SEWAGE DISPOSAL SYSTEM

P 49240
A Repair

PROPERTY OWNER Geneva Knill

REPAIR - PURPOSE - To repair failing septic system.

INDICATE NORTH - NAME ADJOINING ROADWAY AS BASE LINE

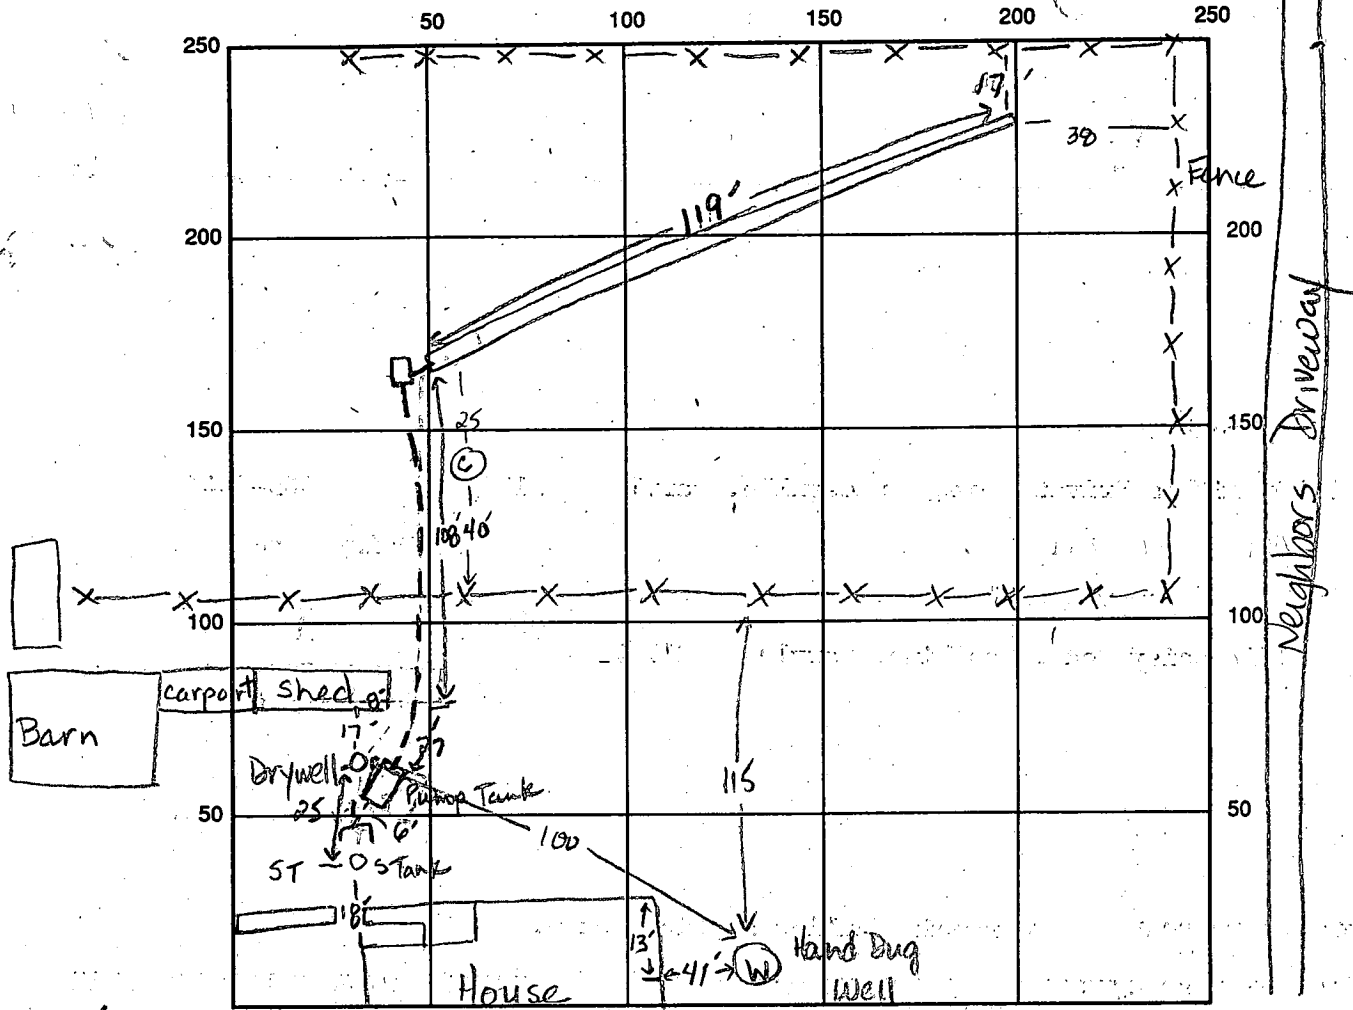
REMARKS: 5-13-93 Add 4 ft to trench and stone, adding pipe & paper. Leave ends open. JEN. 5-13-93 OK to cover trench. JEN
 5-14-93 Dist. box needs divider. Force main in, covered. Need connection between septic and pump tanks. JEN
 NO FURTHER INSPECTION REQUEST AS OF 5/21/95 - SYSTEM PRESUMED OPERATIONAL.
